## Department of Energy

This is in response to your January 7, 2010, letter to Dr. Steven Chu, Secretary of Energy, requesting additional information prior to acceptance of Revision 5 of the Department of Energy's (DOE) Implementation Plan (IP) for Defense Nuclear Facilities Safety Board's Recommendation 2001-1, *High-Level Waste Management at the Savannah River Site (SRS)*. Your letter expressed concern with two commitments in Revision 5: 1) Startup of the Salt Waste Processing Facility (SWPF) and; 2) Return of Tank 48 to waste service being delayed by approximately four and five years, respectively.

**ENCLOSURE 1: RESPONSE TO DEFENSE NUCLEAR FACILITIES SAFETY BOARD LETTER REGARDING IMPACTS OF DELAYS IN SWPF STARTUP AND TANK 48 RETURN TO SERVICE**

**Figure 3: Usable Type III Tank Space Impacts**

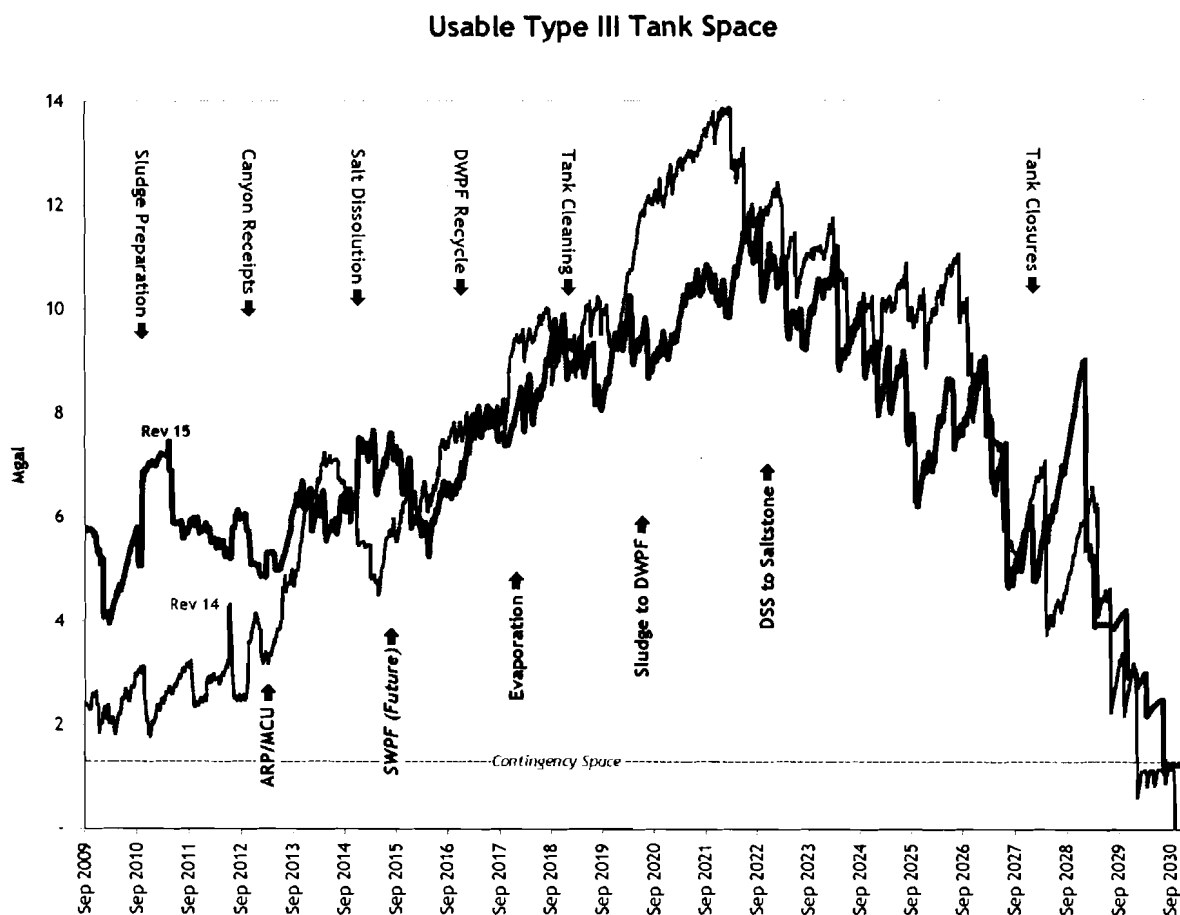
Figure 3 compares a forecast of usable tank space from the present through completion of the cleanup mission, as displayed in appendices of Revision 14 and Revision 15 of the System Plan. The reduction in usable tank space after 2023 is indicative of tank closure. The graph also indicates the unit operations that either create usable tank space or utilize tank space. Figure 3 indicates a near term minimum of 4 Mgal of usable tank space, or 2.7 Mgal after deducting the reserved contingency space, which is a result of efficiently managing the unit operations which produce or consume space.

Ongoing Risk Handling Strategies: Data shown in Table 1 indicate that approximately 12 millions gallons of usable space have been created over the last three years from (1) evaporator operations, (2) DWPF vitrification, (3) Interim Salt Disposition Process Treatment; and (4) saltstone disposal. This valuable space has been used to: (1) remove waste from and clean old-style tanks; (2) prepare, qualify, and treat sludge waste for disposal; (3) prepare, qualify, treat, and dispose salt waste; and (4) support nuclear materials stabilization and disposal through H-Canyon.
